SB-10052359-3401SI B13 07 12
Fuel SystemsMay 2013
Technical Service

This Service Information bulletin supersedes SI B13 07 12 **dated March 2013.**

SUBJECT**N63 and S63 Engine: High-pressure Fuel Injector Replacement Procedures****MODEL**

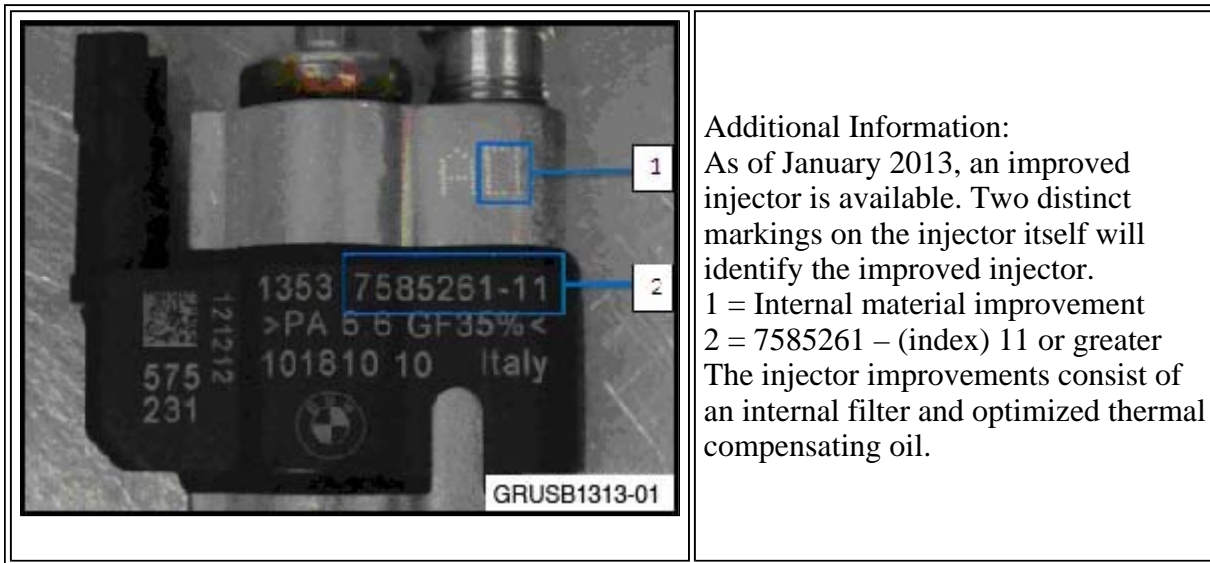
As of January 2013, an improved injector is available. Two distinct markings on the injector itself will identify the improved injector.

1 = Internal material improvement

2 = 7585261 – (index) 11 or greater

The injector improvements consist of an internal filter and optimized thermal compensating oil.

IMPORTANT: Injectors with index 11 and higher have a different calibration and construction than injectors with index 10 and lower.

Use **P/N 13 53 8 616 079** when replacing the injector(s).
